工程指示 / 要求簡箋(E.I.)

工程指示編號：EI / 4231 / 21

工程名稱：啟德 6551

工程項目：VMU 窗拆圖

WINDOW MARK	W1/P T6 21 nos.
LOCATION	FLAT A STO AT 2/F TO 26/F FLOOR (T6) (4,13,14,24/F OMITTED)
GLAZING	G8
WINDOW FRAME	50mm ALUM. WINDOW SECTION

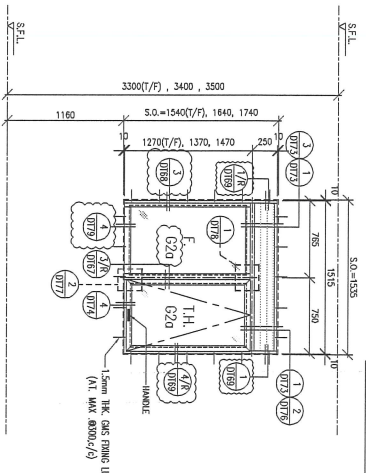
1) VMU T6-W1,W5

2) W1 為 50 料，欠料請使用鋁板摺;W5 為 70 料 中企中橫使用 853 代替

3) 窗玉，膠條 原用 856 設計
